Re: Planning Application to An Bord Pleanála for Proposed 220kV substation, associated 220kV underground grid connection, cabling and associated works on a site of 1.8 hectares at Toomes and Monvallet, County Louth.

Application ref: ABP-315456-23

Malone O'Regan Environmental has been commissioned by Strategic Power Projects Limited to prepare an Addendum to the Environmental Report (ER) that was submitted in support of a SID application (Reference 315456-23) in support of a response to An Bord Pleanála letter dated 31st July 2023.

SHEET NUMBER
05895-DR-003

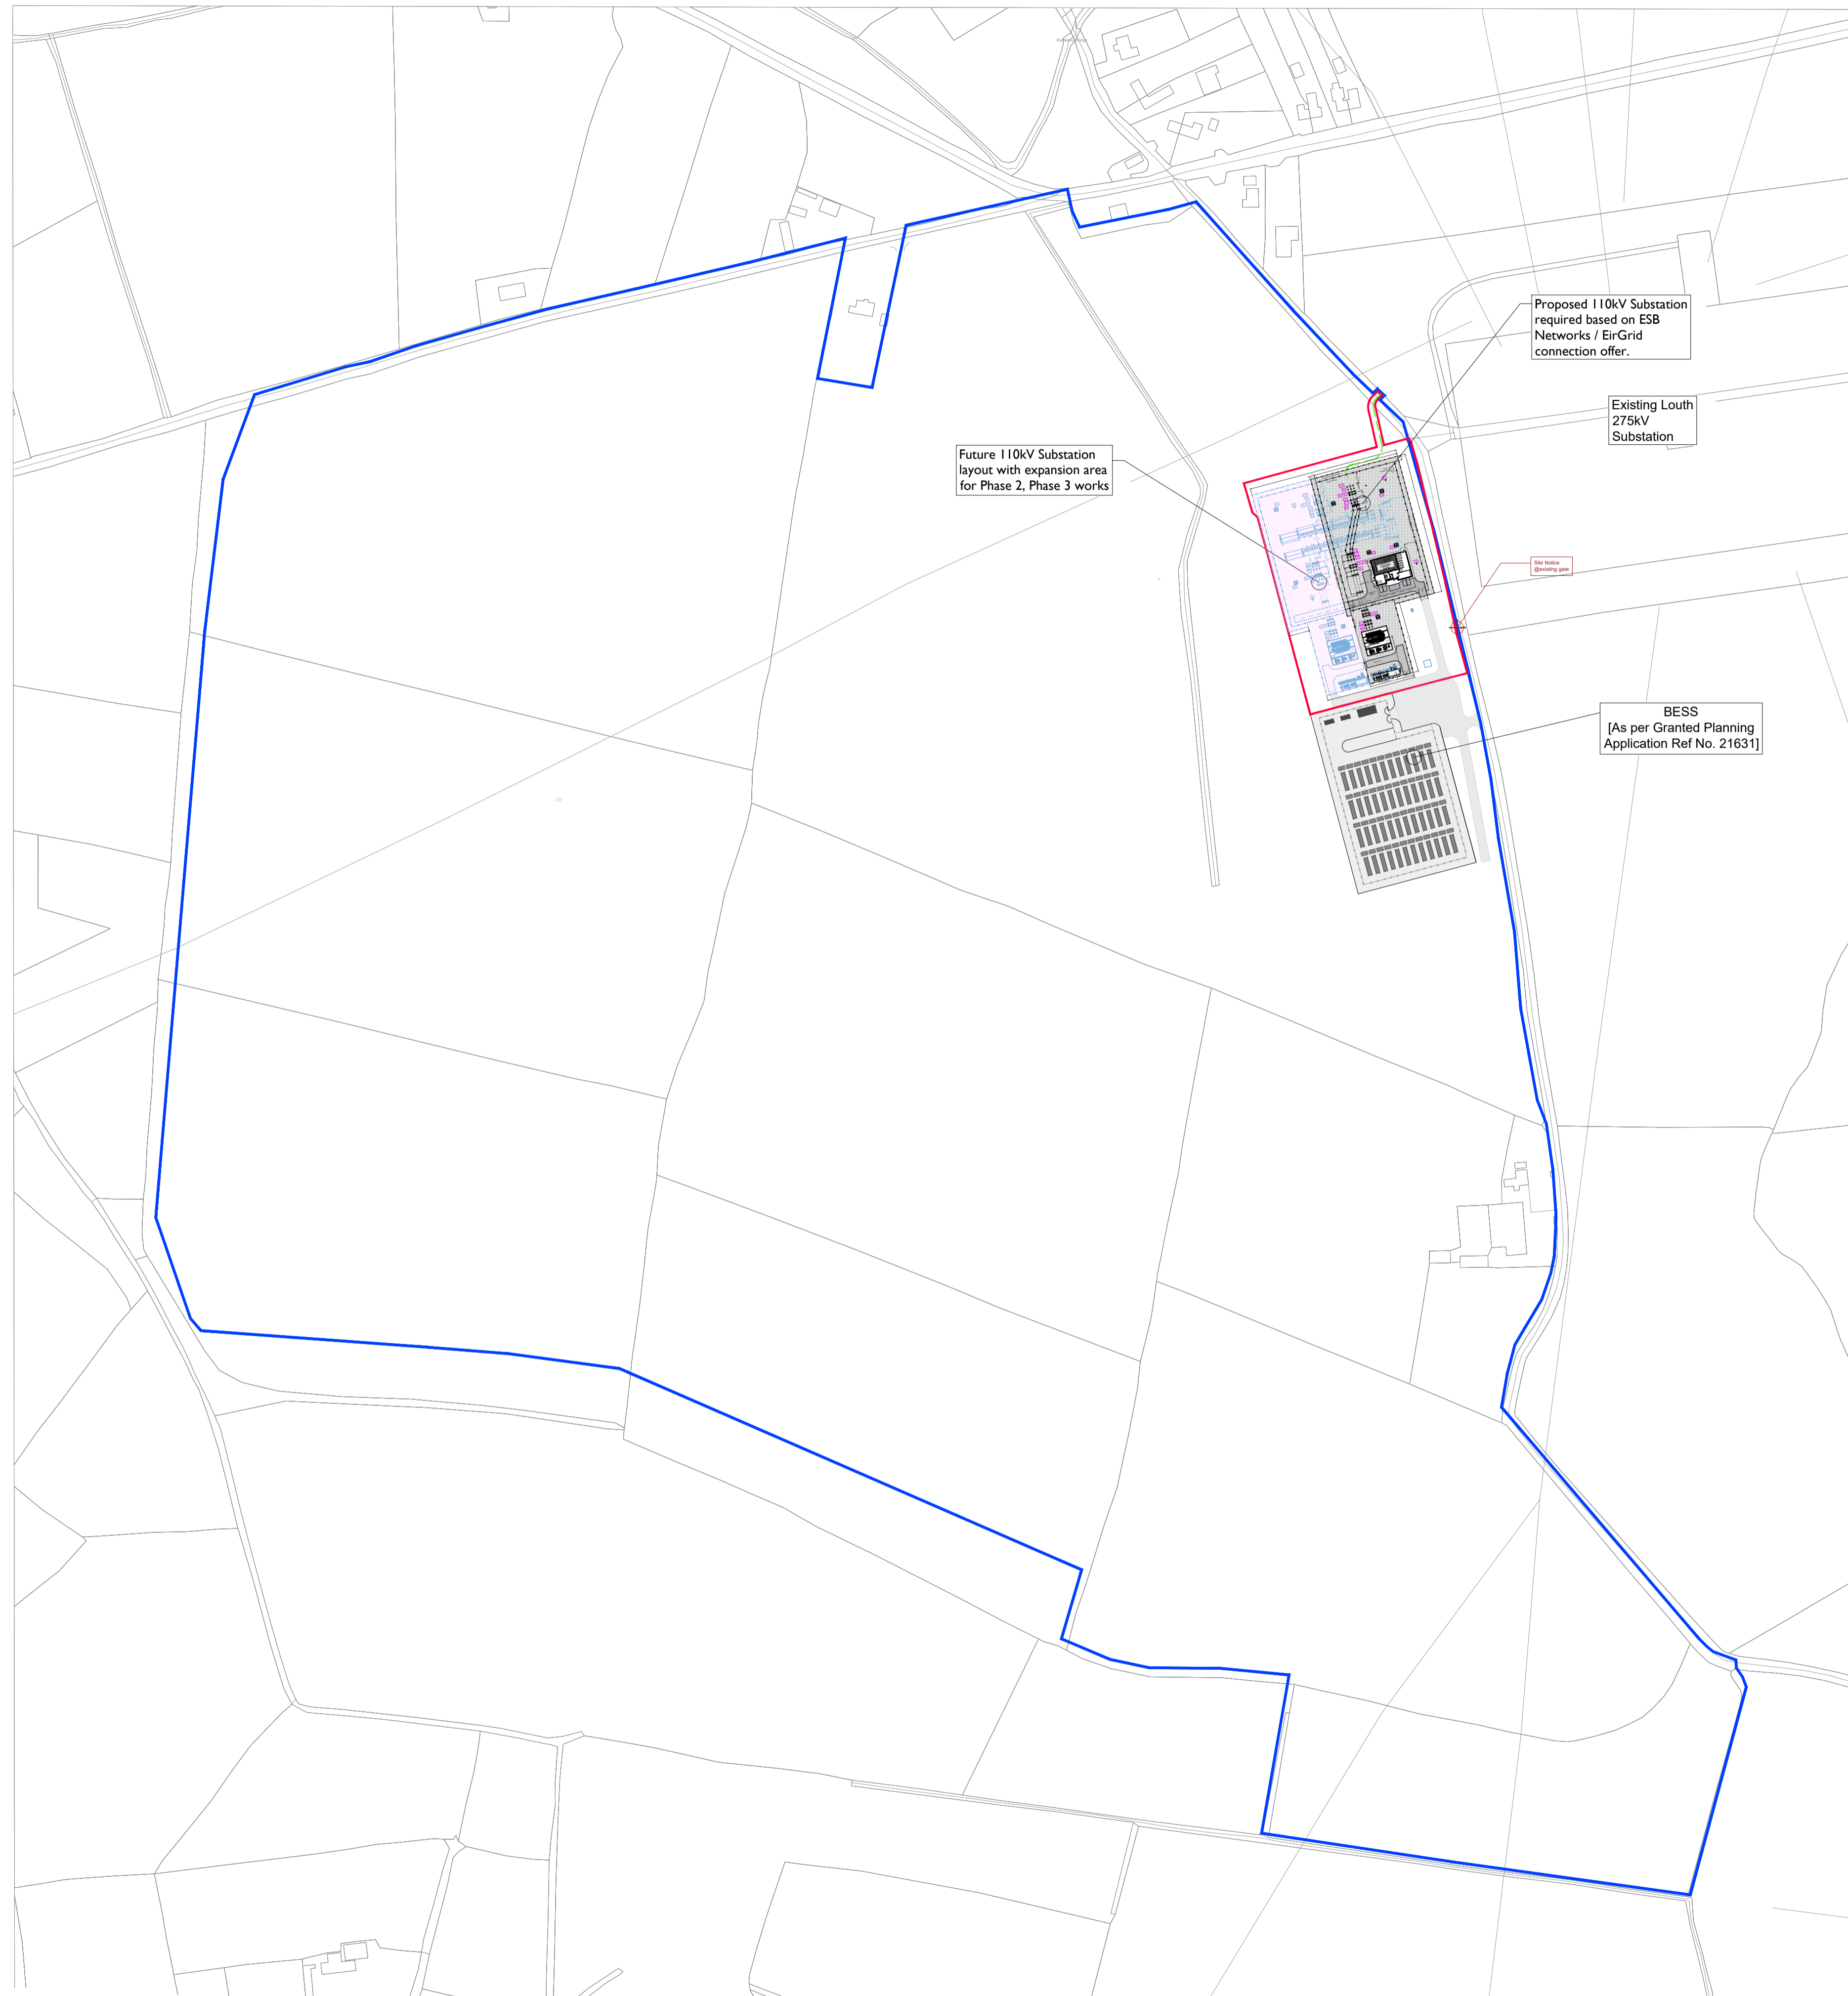
In response to the TII submission, we wish to present an alternative design proposal to the Board for their consideration, that would negate the requirement for any oversized loads on the national road network. This alternative design would be based on the installation of 2 No. 110kV substations instead of 1 No. 220kV substation. This alternative design proposal should the Board be willing to permit it would match the 220kV power capacity of the current proposal, but it would just be delivered via a different design arrangement. As there would no longer be a 220kV transformer, the requirement for the specialist commissioning equipment and associated oversized loads would be negated.

Additionally, the footprint layout and design of 2No. 110kV substations, as per the alternative layout and design, is not materially different to the 2 x 37kV substations already permitted on this site under (Planning Ref: 21/631). The suggested alternative would simply be built instead of the 2 x 37kV substations. The footprint, layout and design of a single 110kV substation is also not dissimilar to that of the 220kV substation.

UGC Grid Connection Option shown thus	
Red Line Planning Boundary shown thus	
Land under control of Applicant shown thus	
Future 110kV Expansion Area	
Future 110kV Expansion Equipment	
Proposed 110kV Substation required based on ESB Networks / EirGrid connection offer.
